# Access Compliance Report

## Public Rights-of-Way

### (Curb Ramps)

Intersection ID: N/A	Main Street: W_W_T_HARRIS_BV	Cross Street: N/A	Location: NE
ADA ID: 57F203438E5D	Ramp Type: PerpDiag	Initial Pass/Fail: Fail	Overall Compliance: No
		Severity Score: 12.5

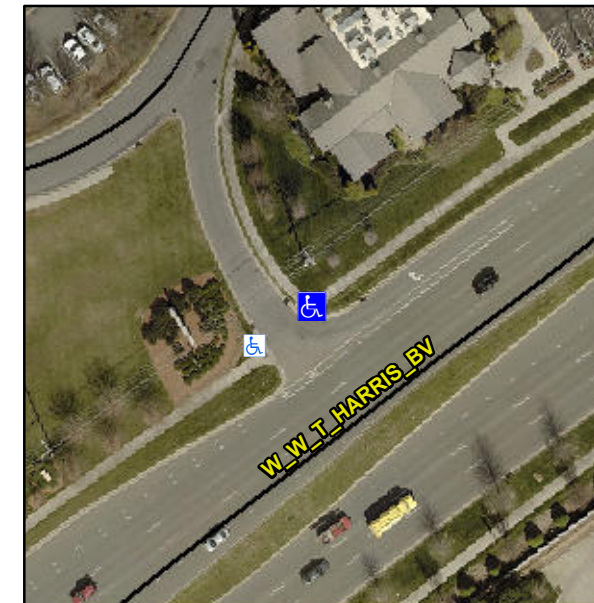
**R304.2.2**

**Remove & Replace Curb Ramp With Two New Directional Ramps or Equivalent.**
